SAN JOSE SHELTER FOR THE HOMELESS

COST FREE CLARIFICATION

CLARIFICATION no: 51  
Date: 2/17/89

REGARDING Reinforcing details for Gunnite Truss

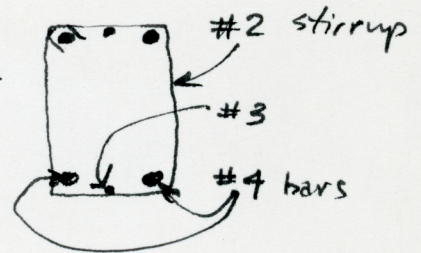
All #10 web bars are bent with 12" tails which parallel main axis of cord.

#2 stirrups can be tack welded to a #3 top and/or bottom to allow for simpler installation of steel. No welds on <sup>any</sup> longitudinal #4 bars.

#2 stirrup

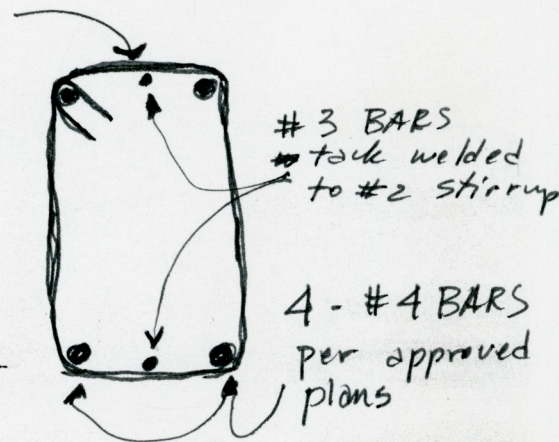
#2 stirrups in cages of main chords can be tack welded to a #3 bar, top and/or bottom, to allow for simpler installation of steel. The #3 bars are in addition to the #4 bars of the cages. There are to be no welds on any longitudinal #4 bars.
